JOURNAL OF COASTAL AND HYDRAULIC STRUCTURES

Review and rebuttal of the paper

Rocking of single layer armour units measured by embedded sensors

**General rebuttal of remarks on first submission, so explaining second revision of:
*Rocking of single layer armour units measured by embedded sensors.***

Figure 2. Schematic representation of the time variations of acceleration a and angular velocity ω during rocking and collision (starting at vertical solid line). Dashed lines show sampling times.

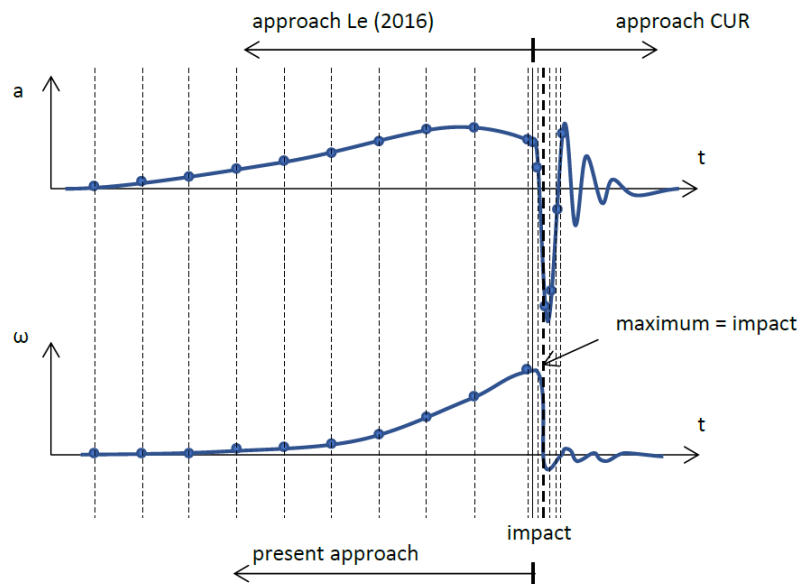
2.8 L41: "a much lower sampling frequency" lower sampling time or higher sampling frequency?

The statement is correct, or at least how we intended it, but apparently confusing. The sentence refers to the approach of L_e , where the motion of the unit prior to the impact is resolved, and which is also utilized in the present paper (see image below). The impulse

during the impact is obtained by integrating the acceleration during the impact with much higher sampling frequency, denoted by ‘approach CUR’ below.

The sentence has been adapted to:

“This method of determining the impact velocity just prior the impact requires a much lower sampling frequency than integration of the acceleration during the short-duration impact.” (Line 50)
